Product Change Notification / RMES-07TLYH580

CCB 6341 Initial Notice: Qualification of MTAI as an additional final test site for selected ATWINC15x0B and ATWILC1000B device families available in 40L VQFN (5x5x0.9mm) package.

CCB 6341
Pre and Post Change Summary
PCN#: RMES-07TLYH580

PCN #: RMES-07TLYH580

Tape and Reel – BQM and Pin1 Orientation

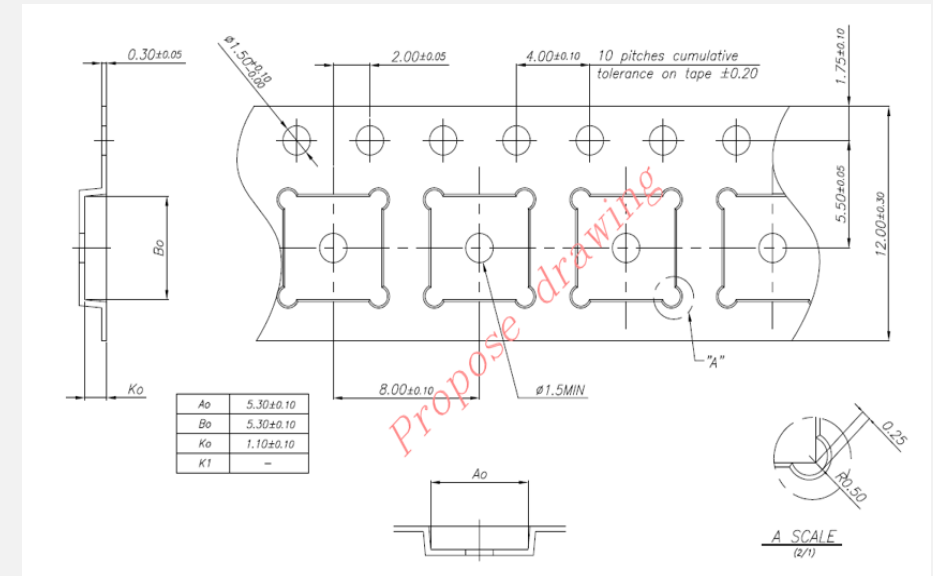
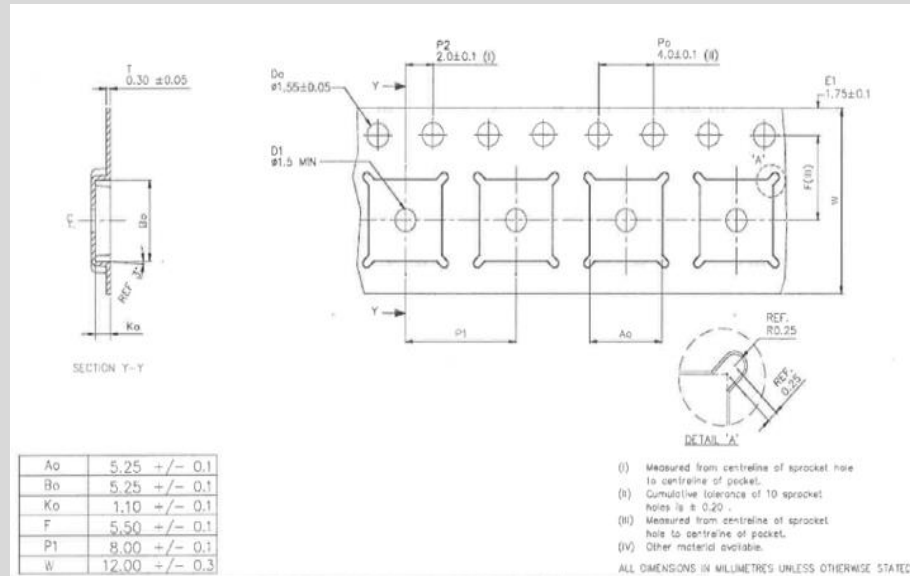
SIGN	MTAI
Base Quantity Multiple (BQM)	4000 per reel	4000 per reel
Pin1 Orientation	Quadrant 2	Quadrant 2

Tape and Reel – Carrier Tape

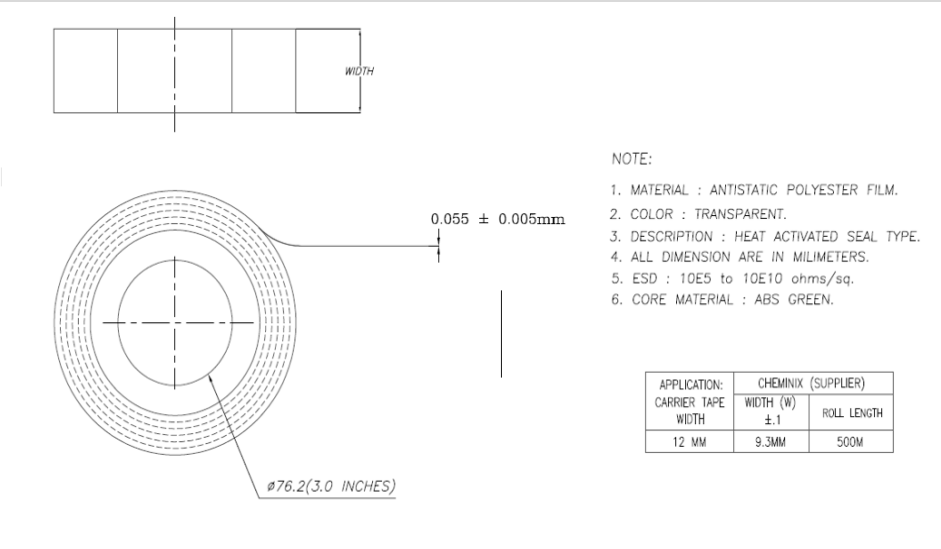
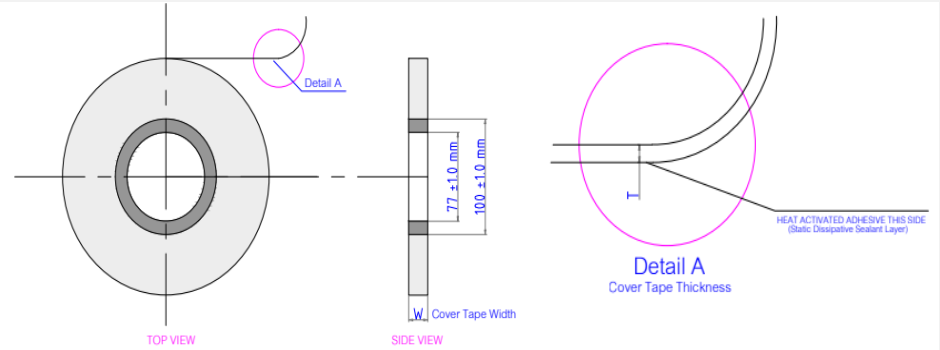
Plant	W (mm.)	P (mm.)	A0 (mm.)	B0 (mm.)	K0 (mm.)	Thickness	BQM	Pin1
MTAI	12 ± 0.3	8 ± 0.1	5.25 ± 0.1	5.25 ± 0.1	1.10 ± 0.1	0.30 ± 0.5	4000	Quadrant 2
SIGN	12 ± 0.3	8 ± 0.1	5.30 ± 0.1	5.30 ± 0.1	1.10 ± 0.1	0.30 ± 0.05	4000	Quadrant 2

Tape and Reel – Cover Tape

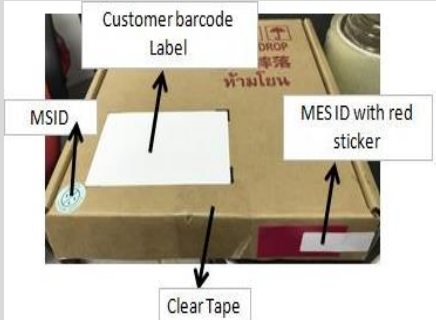
Plant	Package	Width W (mm.)	Thickness T (mm.)	Color	Sealing Methodology
MTAI	VQFN 5x5x0.9mm	9.05 +0.05 / -0.15	0.050 ±0.010	Clear	Heat Seal
SIGN	VQFN 5x5x0.9mm	9.3 ±0.1	0.055 ±0.005	Clear	Heat Seal

Tray

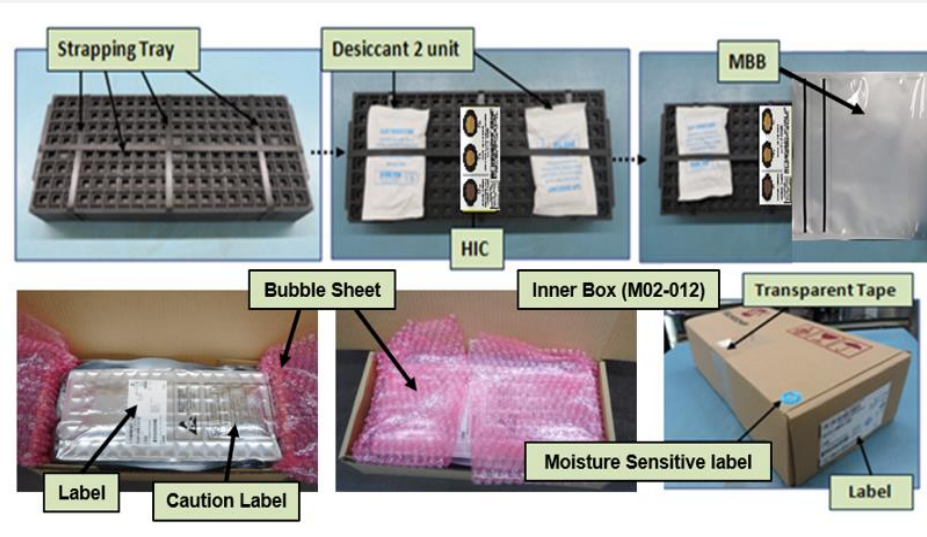
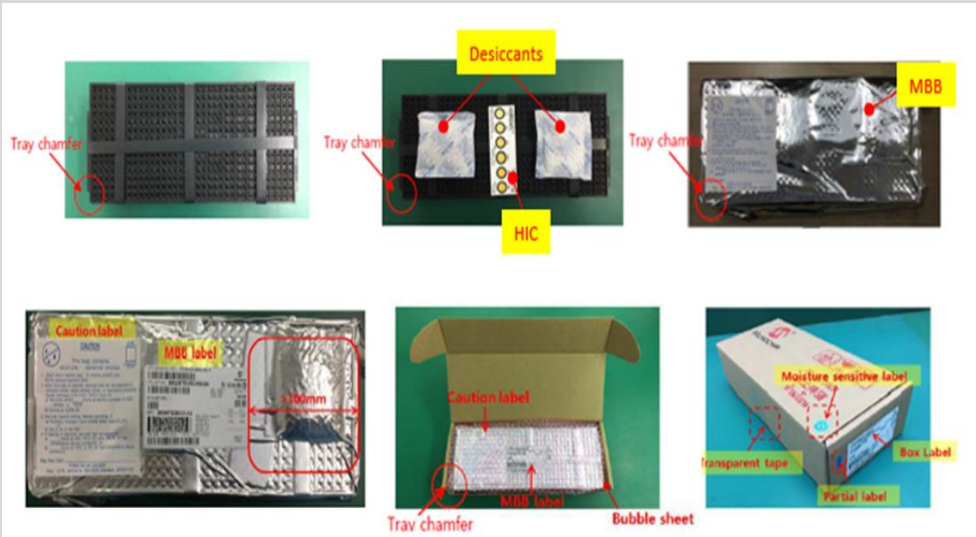
Plant	Bakeable (Temp C)	Row	Col	Unit per Tray	Color	Tray Stack
MTAI	150C	14	35	490	Black	10+1
SIGN	150C	14	35	490	Black	10+1
